Revision: J
Our ref: 12548316

RE: New High School in Jerrabomberra SSD RFI

Table 1 DPIE RtS Letter

**Detailed Submission - New High School at Jerrabomberra (SSD-24461956)
Objection to Proposal**

ELEVATION

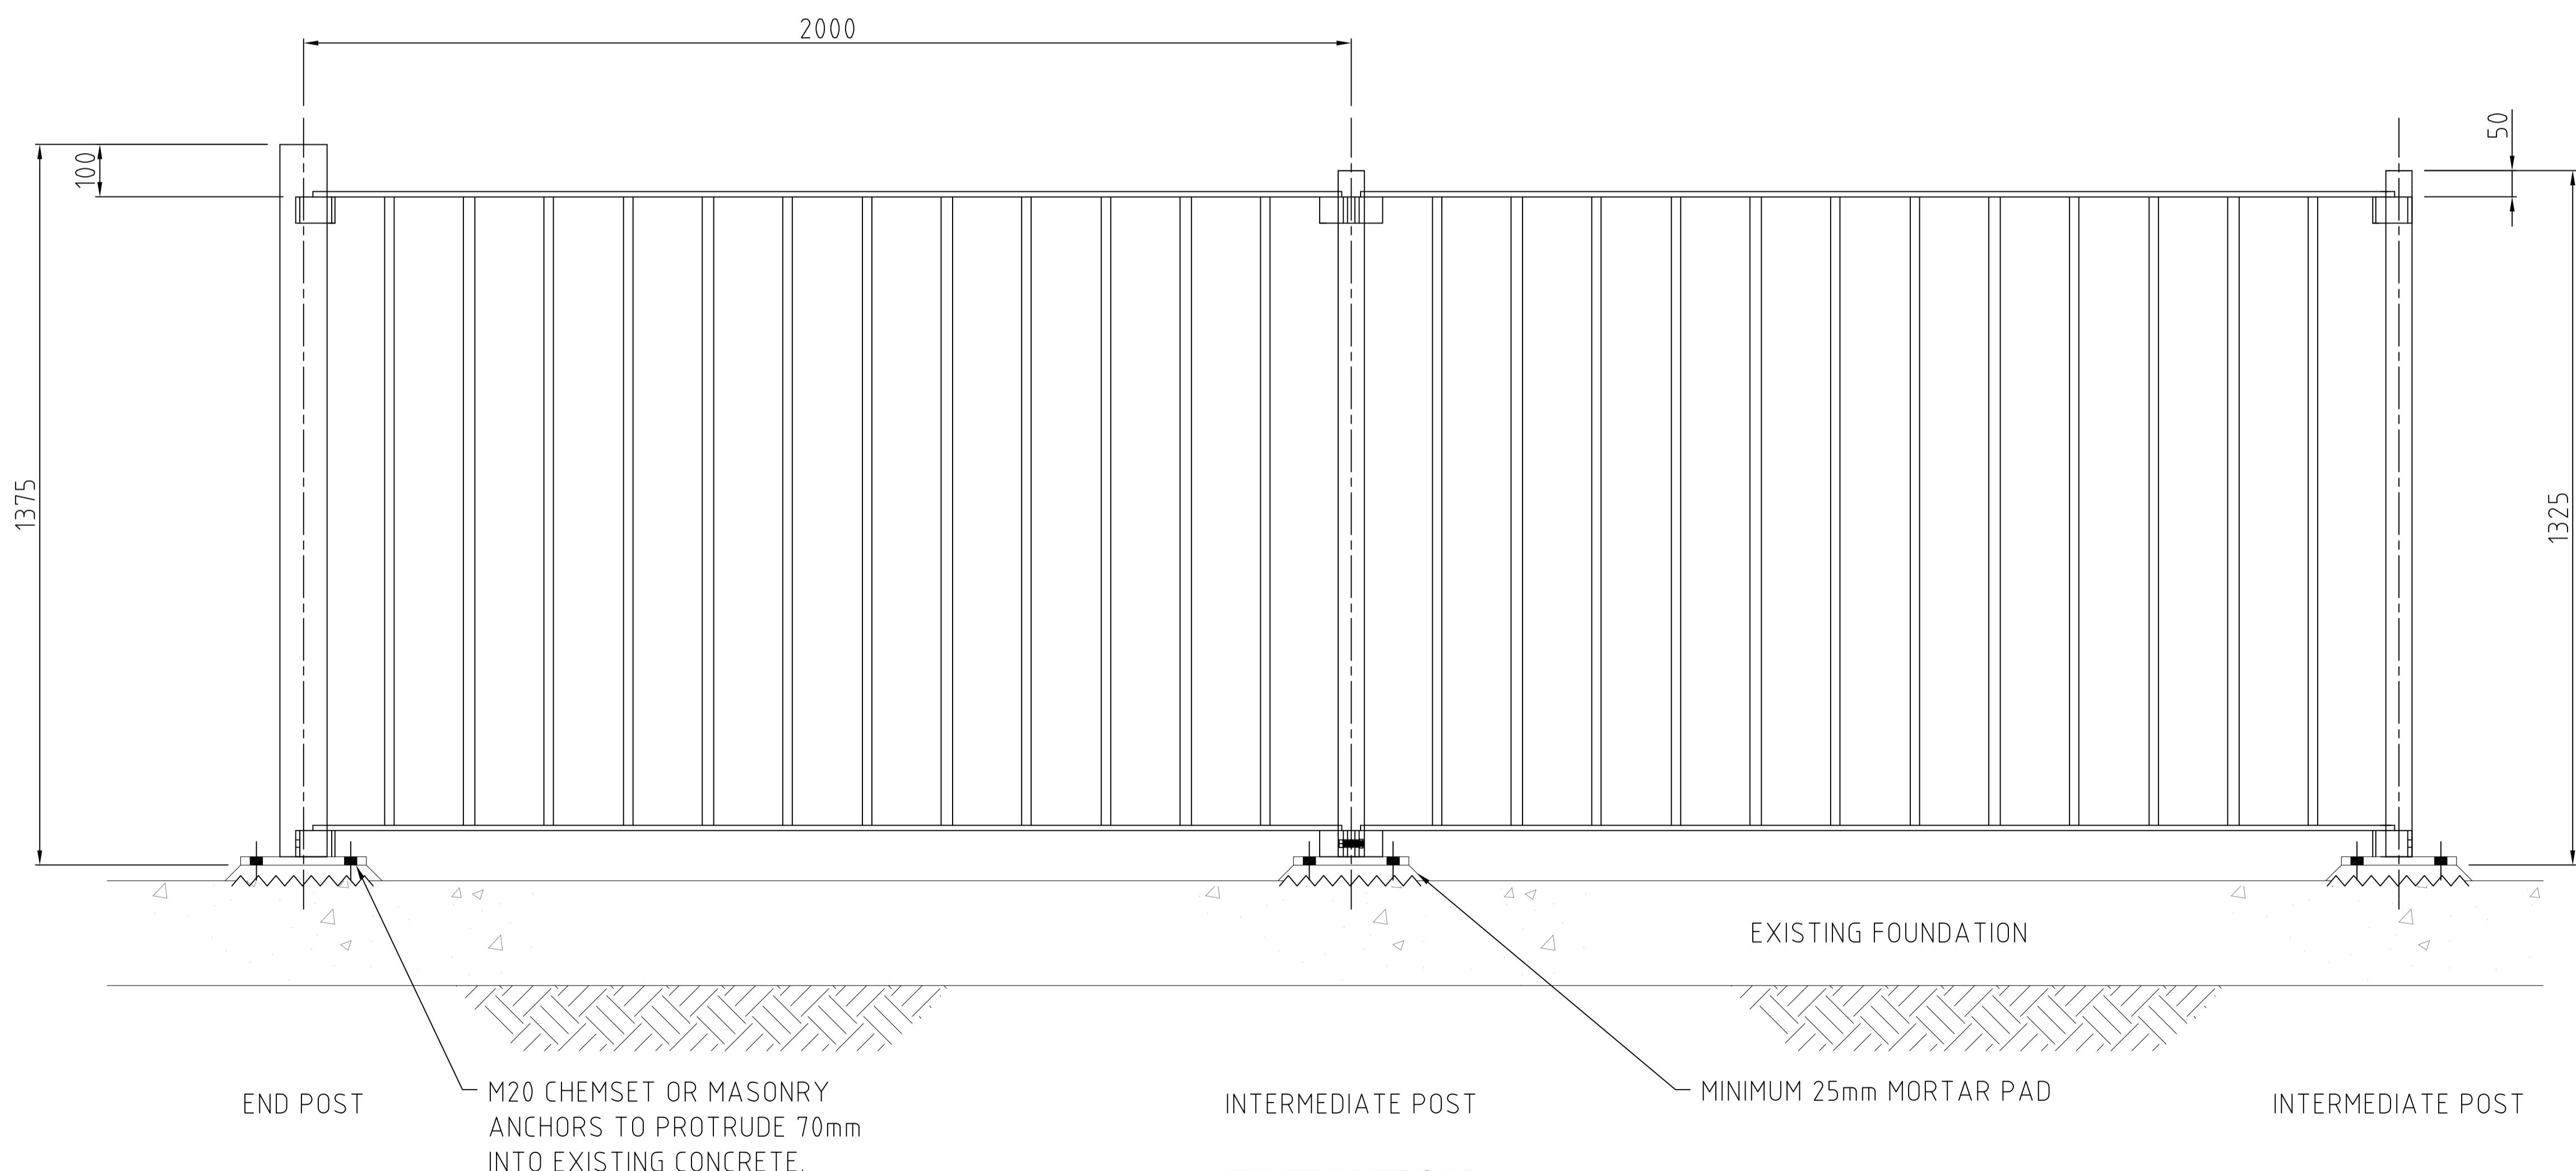
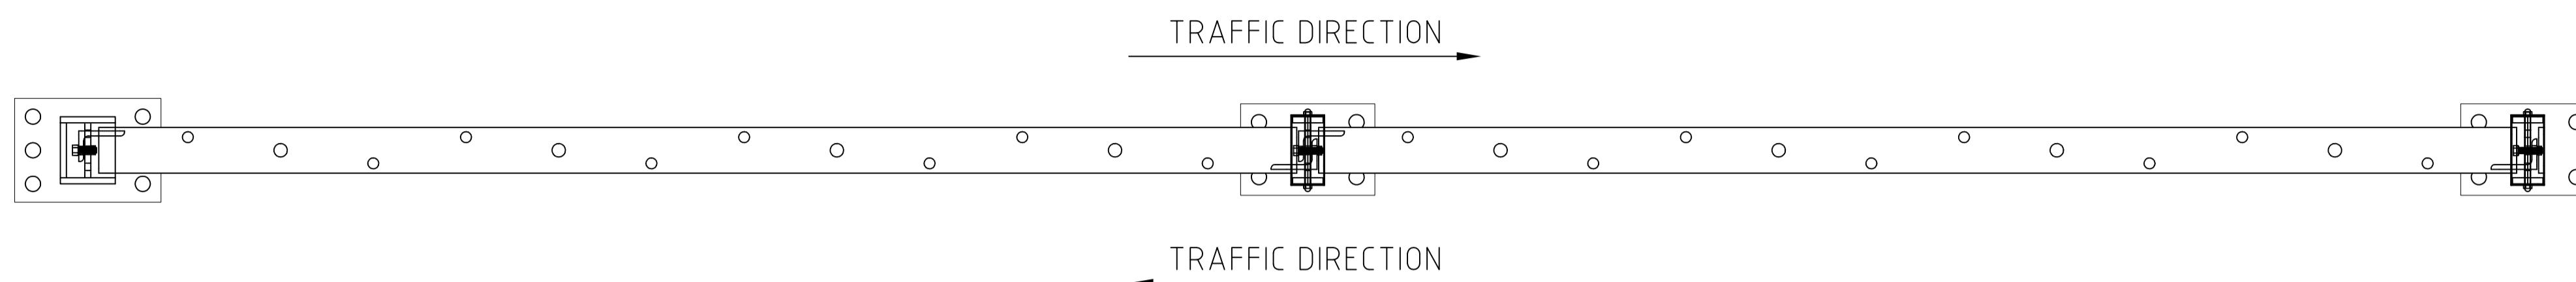
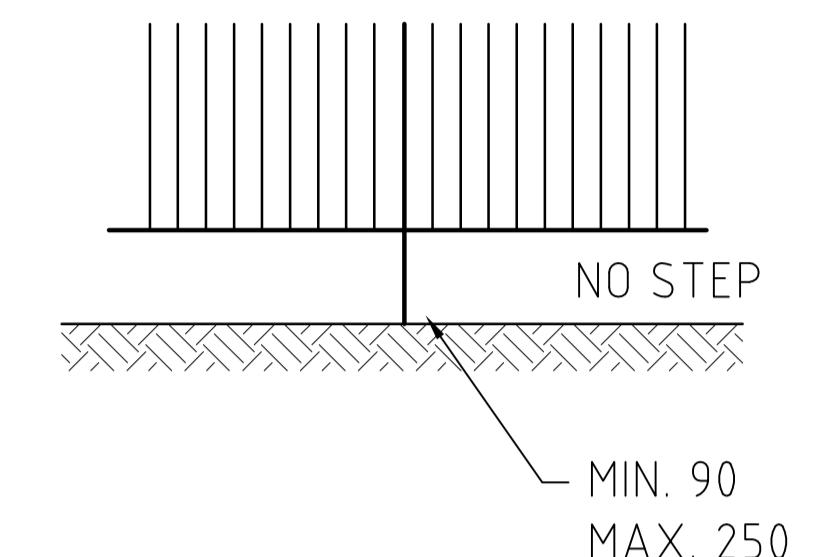
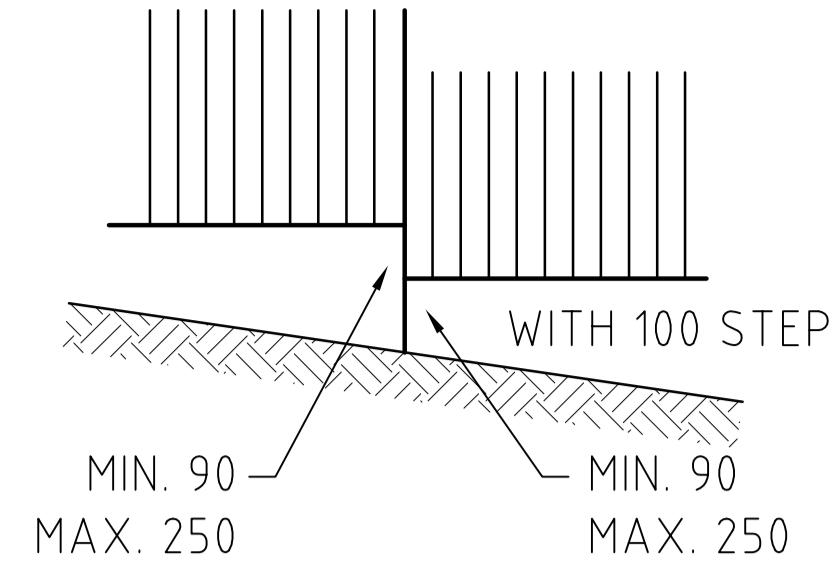
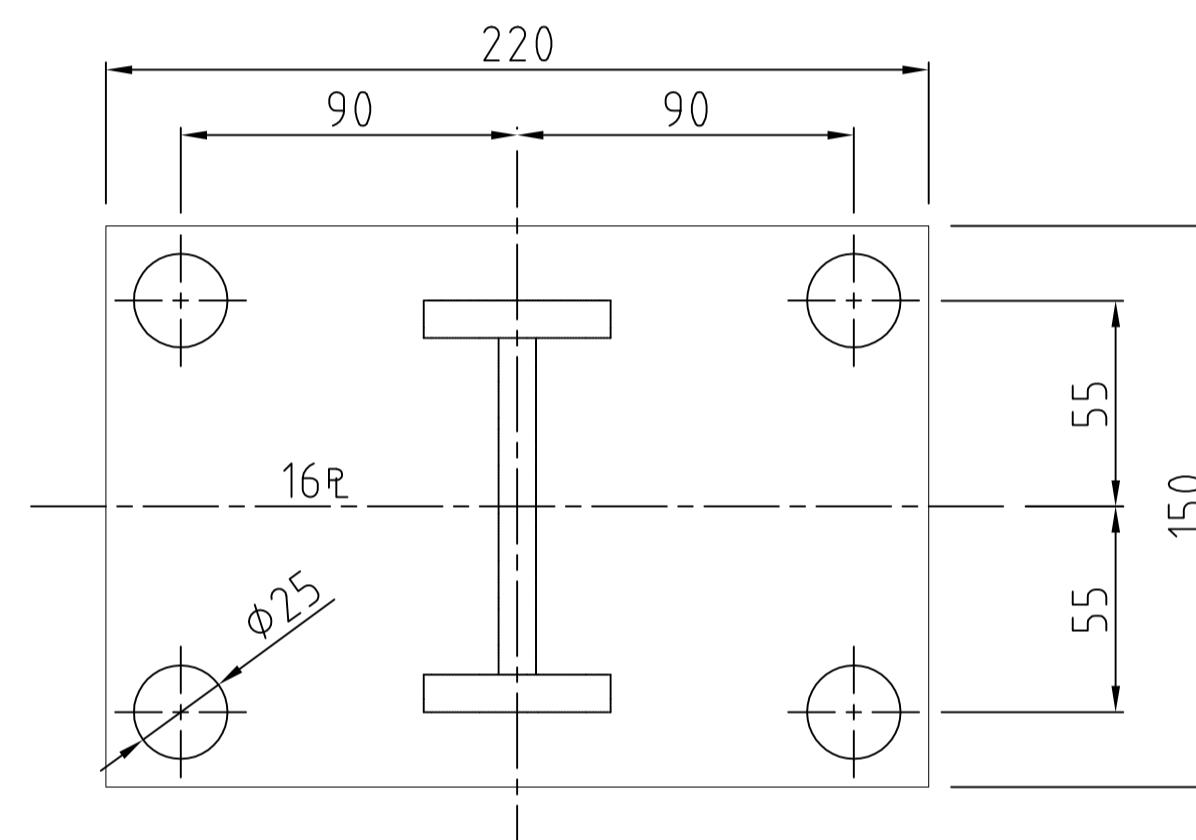
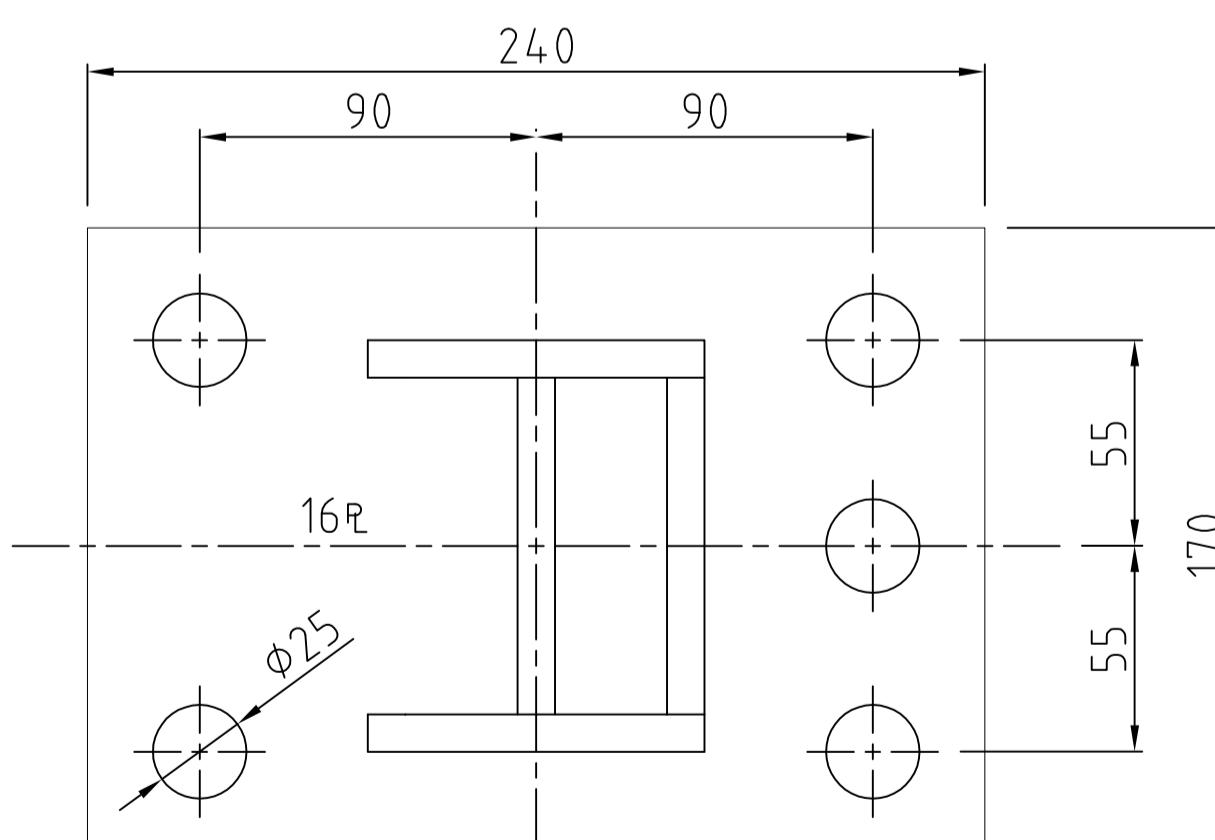
Fencing will also be provided within the median of Environa Drive to discourage students from being dropped off / picked up on Environa Drive, with the location/alignment shown on drawings provided in Appendix E; Pedestrian road Safety-Barrier Fence TP-0001 and fencing type illustrated in, Type 1 Pedestrian PF-SD-003.
